Product hierarchy no. *	Part no.	SBU	Type / Description	Customer part no.		
SBU PG PUG Type			·	·		
80 084 002 0000006147	See list below	EMC	FMW-55			
*SBU (2-digit) / PG (3-digit) / PUG (3-digit) / Type (10-digit)

## 2 Type of change

Product Change Notification				PCN FMW-55 case 10 redesign				
owner	creation date	release date	released by	change order no	rev	page	D40 042 702	
segatro	12.03.2020	12.03.2020	canoniar	2018652	Α	1 of 2	D10-043-702

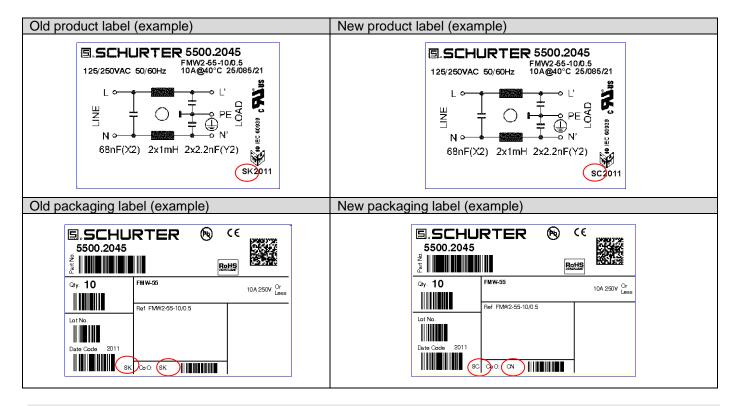
- Change of product appearance due to new nickel-plated steel case instead of aluminium case
- Different shape of plastic part for external quick connector terminals
- Moved position and turned protective earth terminal to a vertical position
- Change of factory code from SK to SC and origin from SK to CN on product and packaging labels
